REQUEST

Current Zoning: R-5 (single family residential)
Proposed Zoning: UR-2(CD) (urban residential, conditional)

Approximately 0.17 acres located at the northeast corner of E. 17th Street and N. McDowell Street.
(Council District 1 - Egleston)

**STAFF
RECOMMENDATION**

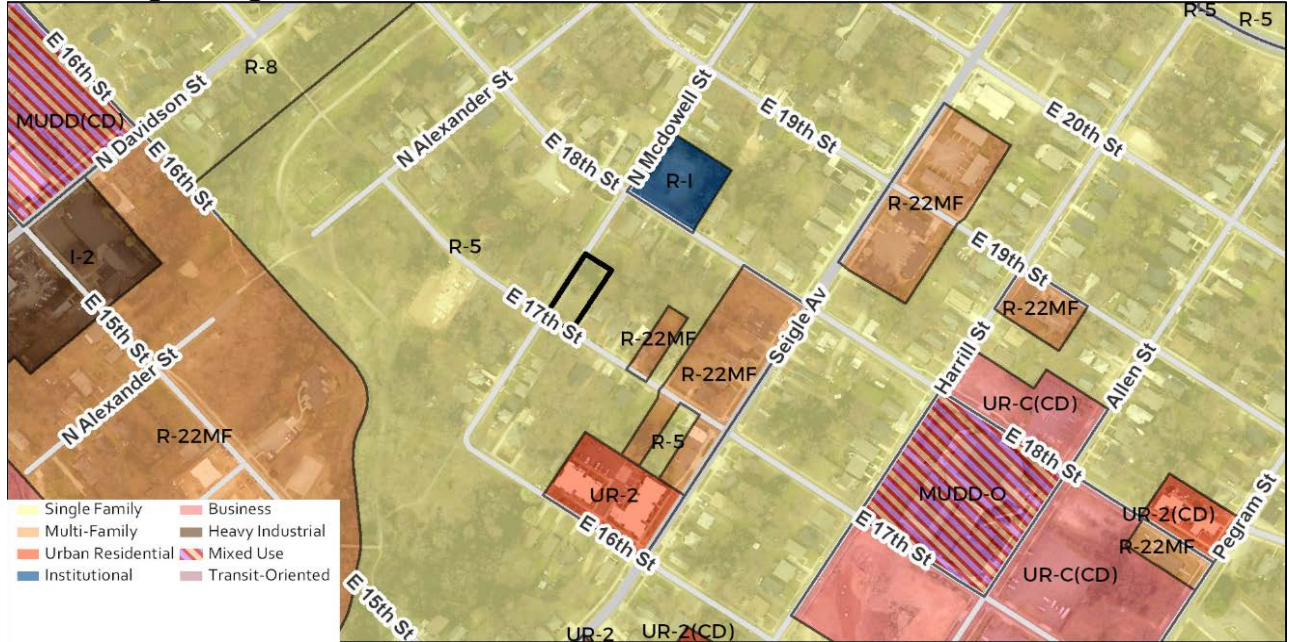
• Proposed Request Details

The site plan accompanying this petition contains the following provisions:

- Maximum of five single family attached dwelling units limited to 40 feet in height.
- One unit will be for-sale affordable at 80% AMI, with a 10-year restriction on resale, or shall be eligible for the in accordance with the City of Charlotte's House Charlotte program. Housing Authority's affordable housing guidelines.

- Site vehicular access via N. McDowell Street.
- Preferred building materials consisting of brick, cedar shake, wood siding, fiber cement siding, stucco, masonry and/or other material approved by the Planning Director. Permitted roof materials include asphalt shingles, composition shingles, wood shingles, tin, standing seam metal, and wood shakes.

- Minimum seven-foot sidewalk along curbside in alignment with the existing sidewalk, and an eight-foot planting strip along both E. 17th Street and N. McDowell Street. in the remaining area between the sidewalk and the property boundary. The planting strip will be increased to eight feet in width if open space is no longer required. A six-foot sidewalk along curbside and eight-foot planting strip will be provided along N. McDowell Street. In order to accommodate tree save, connections to existing sidewalk and grade of the property, the sidewalk and planting strip may be inverted, with the sidewalk located at the back of curb and the planting strip located inside of the sidewalk.

- A retaining wall may be located between the sidewalk and planting strip.
- A minimum four-foot walking space will be provided between any sidewalk obstruction and edge of curb or any adjacent retaining wall.

- Providing 429 square feet of tree save area, and 1,115 square feet of replanting area.
- Providing a site distance diagram exhibit.
